CALIFORNIA COASTAL COMMISSION

STAFF REPORT: APPEAL OF EXECUTIVE DIRECTOR DETERMINATION

DISPUTE RESOLUTION NO.: A-220-80-A2-EDD

APPLICANTS: Graham and Brenda Revell

EXHIBIT 4
 A-220-80-A2-EDD
 Approved Stairway
 Plans (1986), 4 Pages

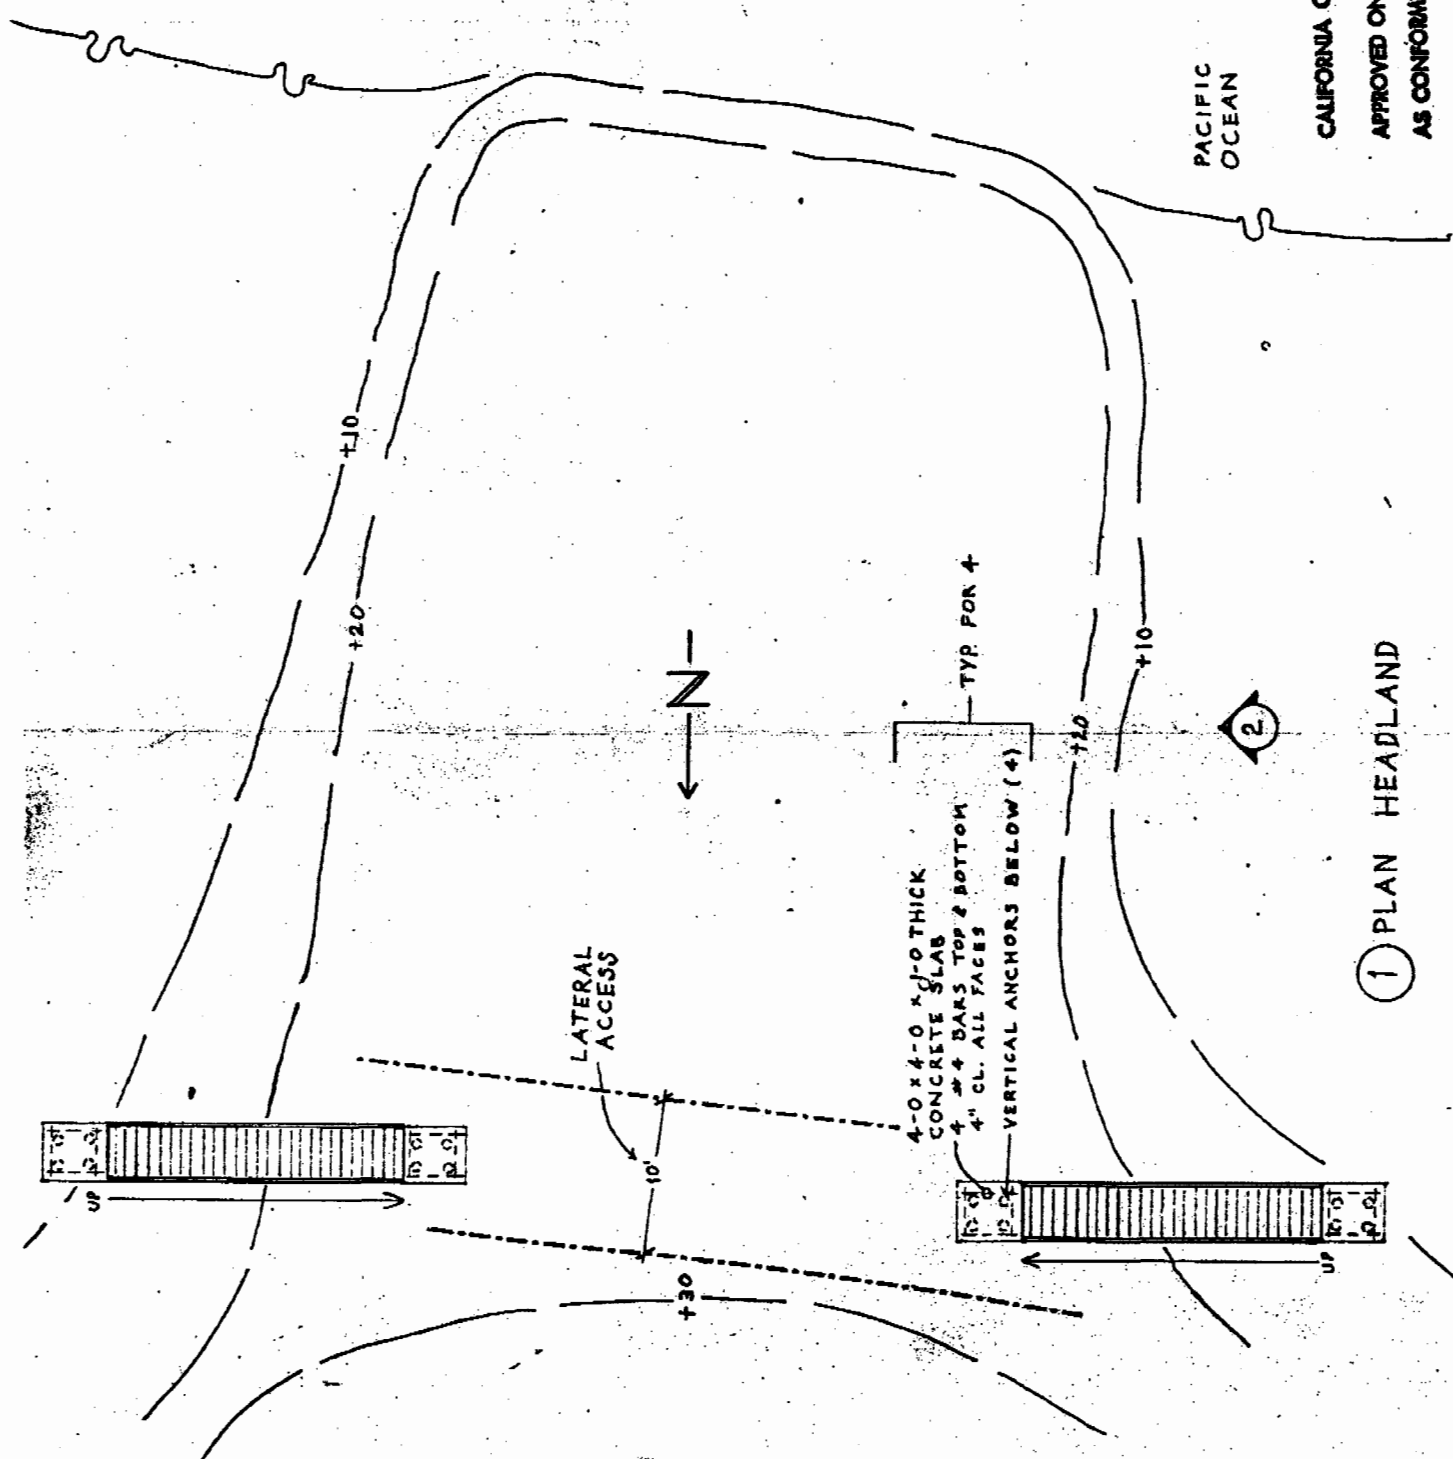
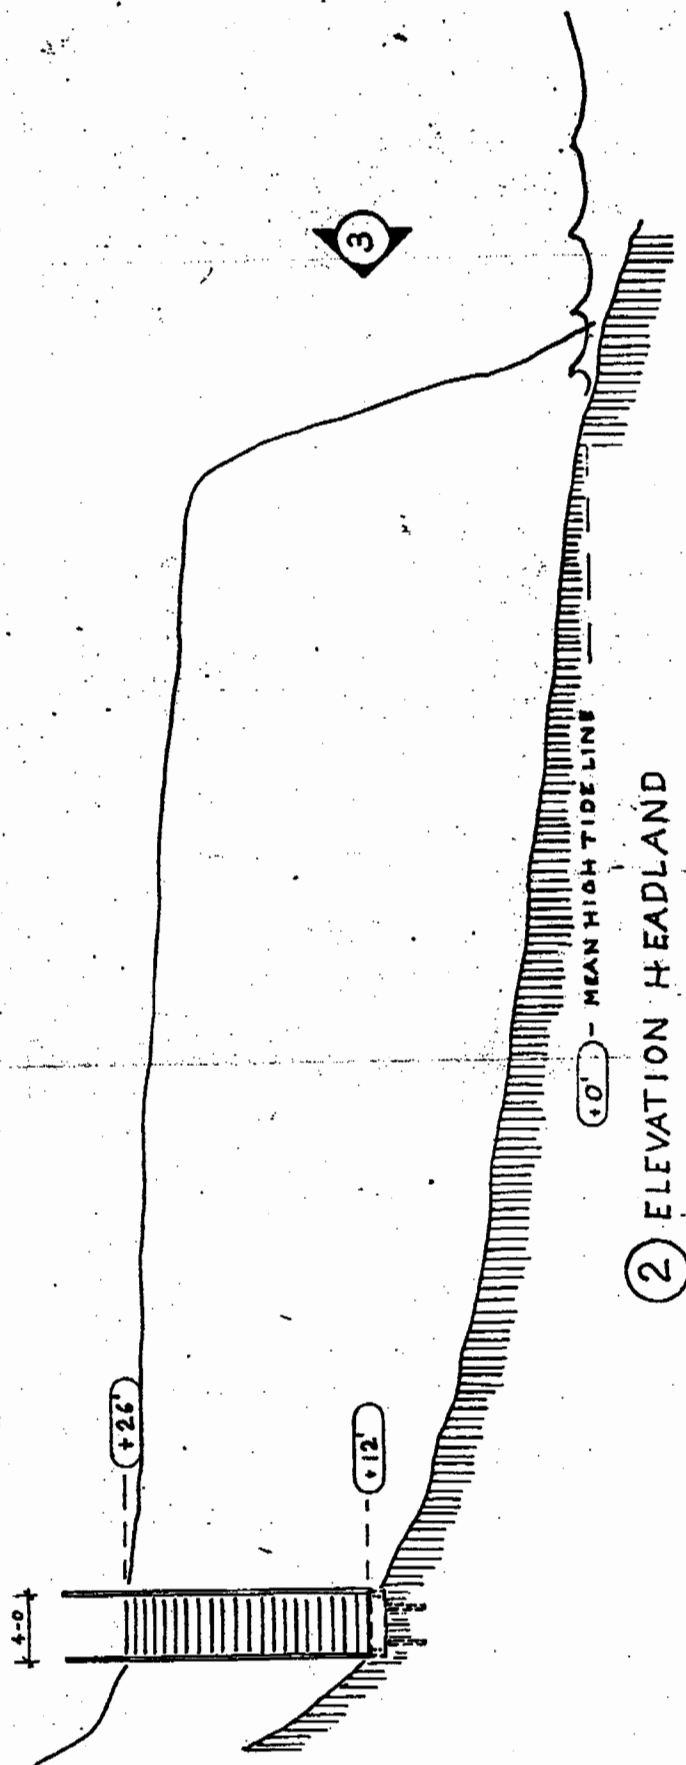
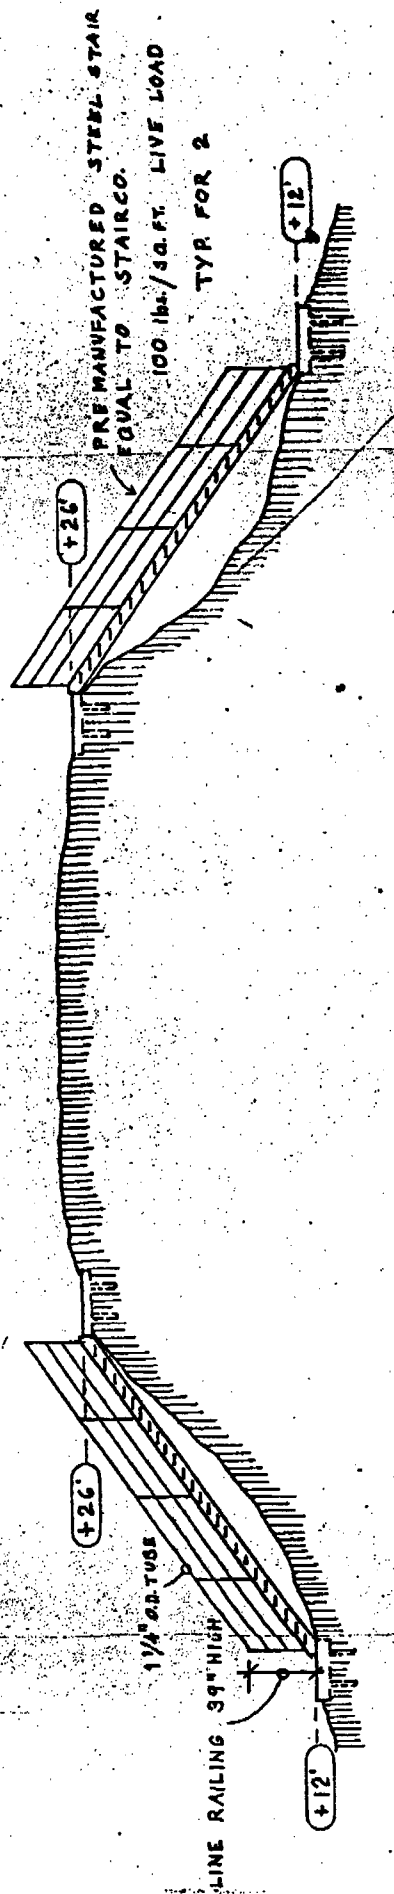
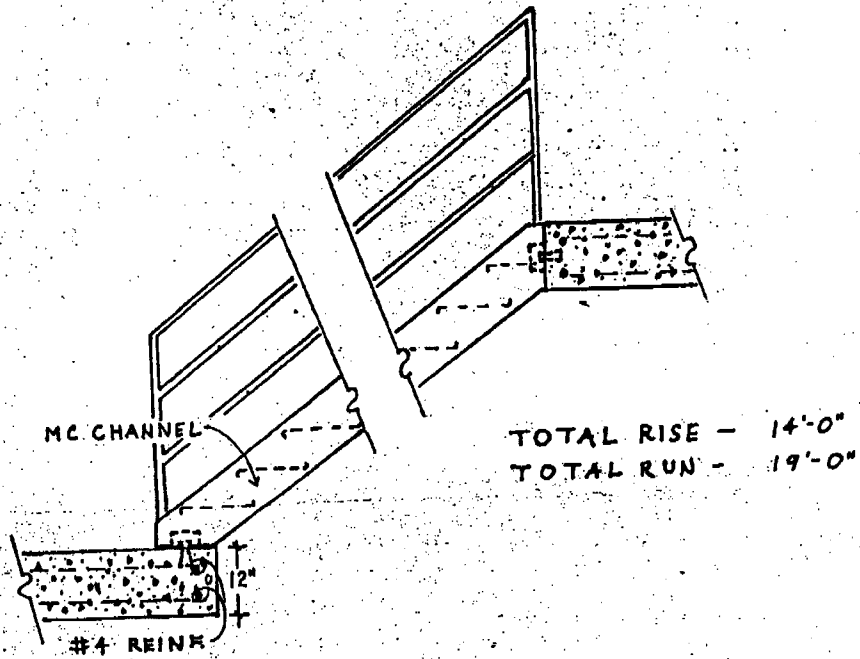
The second conclusion focuses on the erroneous premise that the only responsibility that the applicants bear under the existing permit is to construct the 1986-approved design (Exhibit 4). That is not true. Even if the 1986 plans would have worked at that time they were approved, and physical changes made that previously approved plan no longer viable, unless and until an amendment is approved, the applicants have the responsibility for fulfilling the obligations of the original 1980 proposal and of Special Condition 2 rather than relying on the conceptual plan previously submitted by the applicant, which is merely a tool to facilitate condition implementation. The applicant for the 1980 amendment proposed, and Special Condition 2 requires, the construction of public access improvements from the shoreline to the headland accessway and back to the shoreline. Public access up and over the headland was found by the Commission to be requisite in the approval of the residential development. The 1986-approved plans are just one means of fulfilling the requirements of Special Condition 2. Other stairways similar to the 1986 design, or alternative design, could be implemented to meet the requirement of Special Condition 2 for public access improvements from the shoreline to the headland accessway and back to the shoreline.

The applicants imply that construction of the public access stairways, pursuant to the 1986-approved plans, would not provide lateral access since the stairways would not reach the beach due to changes in sand supply at the base of the headland. This concept is based on the erroneous premise that the maximum responsibility that the applicants must accept for fulfilling the terms of Special Condition 2 of the approved permit, is to construct the 1986-approved design.

The applicant submitted project plans for the construction of two stairways from the headland to the beach which were approved by the Commission in 1986. These plans may have indicated an adequate concept to implement the appropriate design at the time that they were approved. That is, the 1986-approved plans (Exhibit 4) show an

Regardless of the previously approved stairway design, there is no evidence that any of the engineering or geologic constraints identified by the applicants have changed since the underlying permit was approved. The only asserted change is the variability in sand elevation at the base of the headland. This change, as detailed in the previous two arguments above, is not considered a changed circumstance but rather a natural part of the beach sand cycle. Furthermore, the approved plans indicate that the stairway would be supported on a pile- or caisson-supported foundation.

Regardless of the previously approved stairway plans, the applicants have the responsibility for fulfilling the obligations of Special Condition 2 rather than relying on the conceptual plan previously submitted by the applicant which is merely a tool to facilitate condition implementation. Any potential past, present, or future changes to the sand elevations on the beach fronting the subject site are irrelevant to the feasibility of constructing the previously approved public access improvements on the subject site in compliance with the required conditions of approval of the underlying permit. Special Condition 2 requires the construction of public access improvements from the shoreline to the headland accessway and back to the shoreline. Public access up and over the headland was found by the Commission to be requisite in the approval of the residential development. The 1986-approved plans are just one means of fulfilling the requirements of Special Condition 2. There may be other alternative stair designs that would meet the requirements of Special Condition 2 that could be implemented. The Weiss Report (2007) itself has described an alternative "stair tower" that might also meet the requirements of Special Condition 2.

In conclusion, adequate lateral access would be feasible at the site because a stairway similar to the 1986 design, or alternative design, could be implemented to meet the requirement of Special Condition 2 to design improvements to provide access from the shoreline to the headland accessway and back to the shoreline.
